Subject: FCC Class II Permission change for FCC ID: T7HR4027
Original Grant Date: 10/27/2019

This is to request a Class II permission change to our product name: DECT Repeater, IP DECT Repeater, Repeater, RFP14 Repeater; (FCC ID: T7HR4027), the device is identical to the previously certified except for the changes as below for details；

Previous Version	New Version

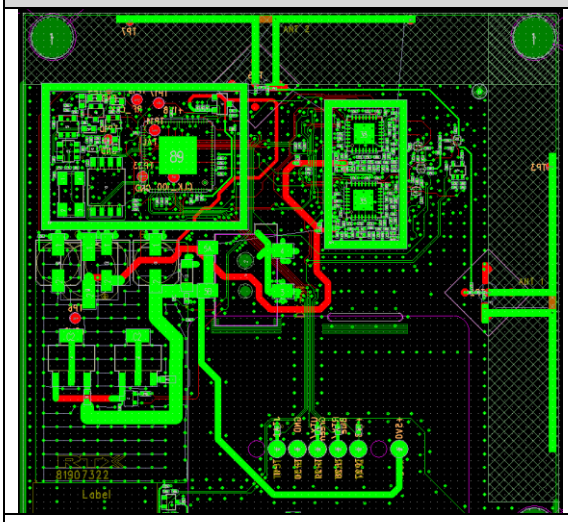
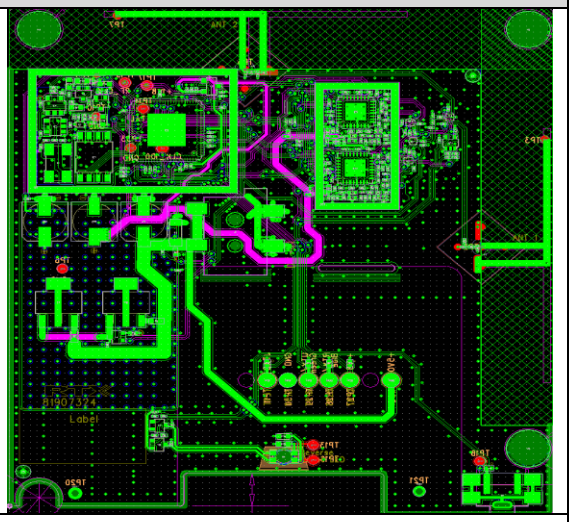
1) Changing the produce name to “Repeater ,IP DECT Repeater,RFP 14 Repeater”
2) Adding model numbers “VCV1302, WAIR-REP-2021, 100dr IP-DECT Repeater, RFP 14 Repeater”.
3) Adding trade names “VoCoVo, Mitel, Wildix, iPECS”.
4) Adding product color.
5) Change PCB Antenna shape but the antenna gain was not changed.

Layer	Previous Version	New Version
Top

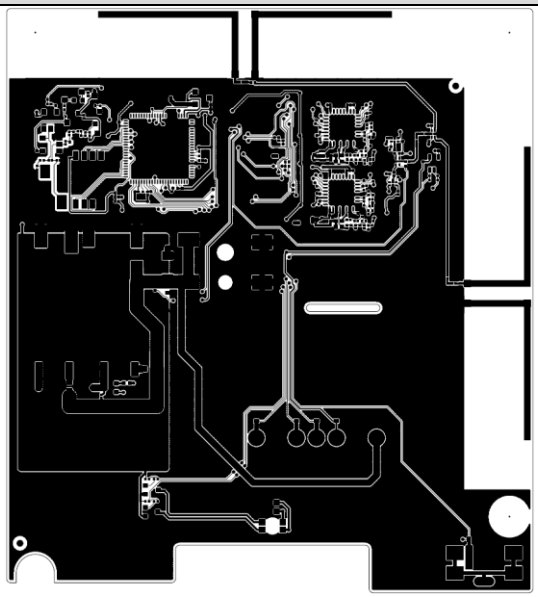
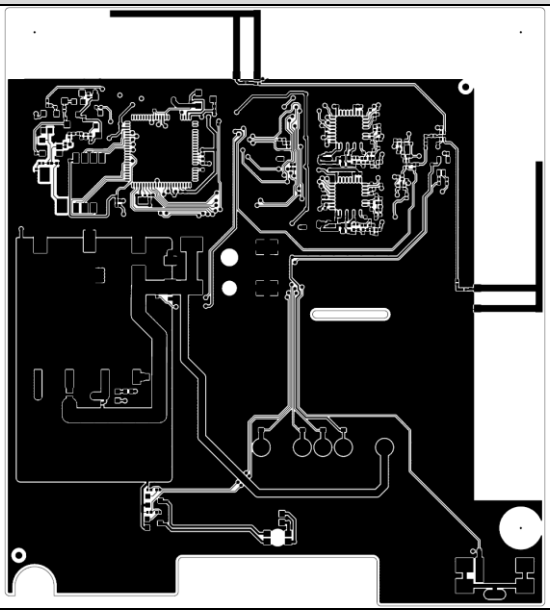
No change except PCB Antenna shape	
Inner 2	/

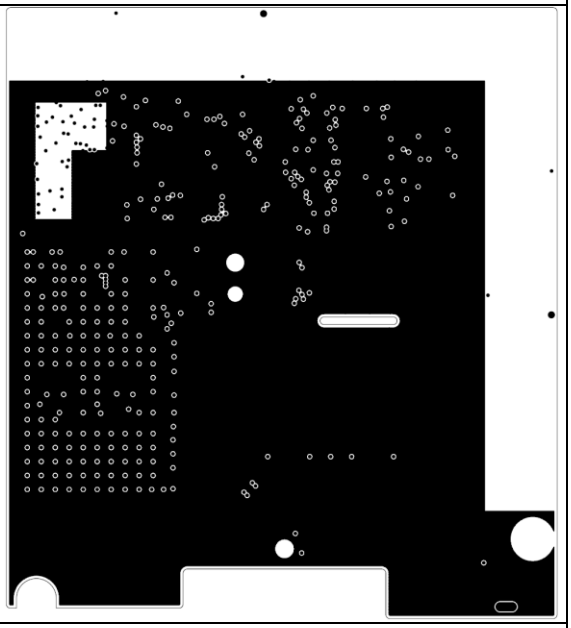
6) Change from 2-layer PCB to 4-layer PCB.
   The change is to add extra ground plan by moving the bottom layer to Inner layer 3 and add ground plan on Inner layer 2 and bottom.

additional ground plan

Inner 3	/

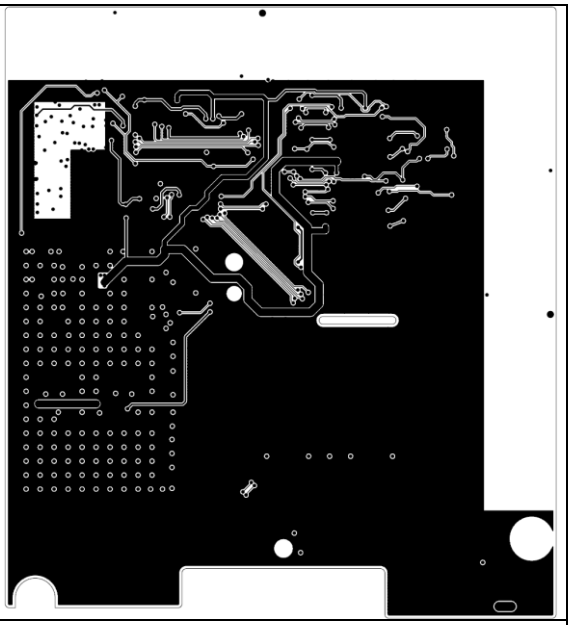
move bottom layer to Inner layer 3	
botto m

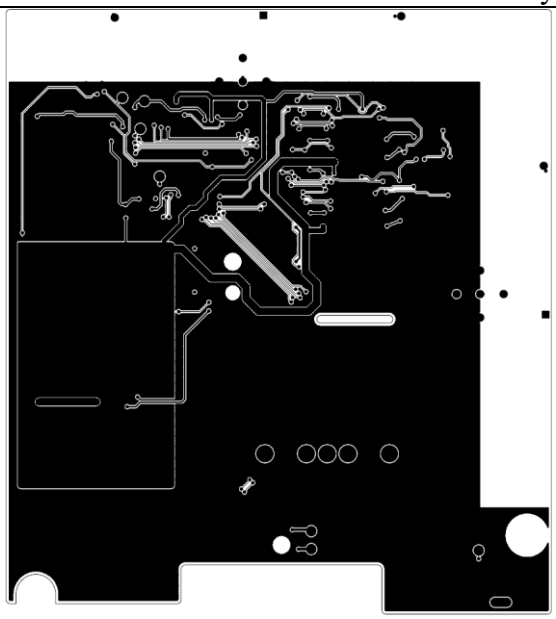
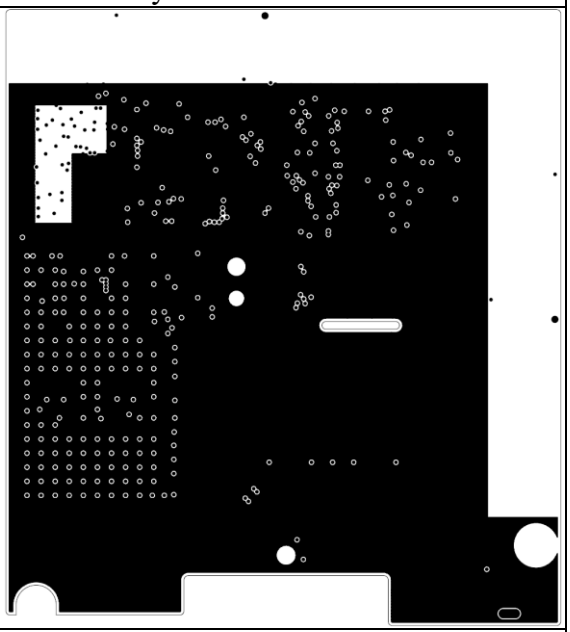
additional ground plan
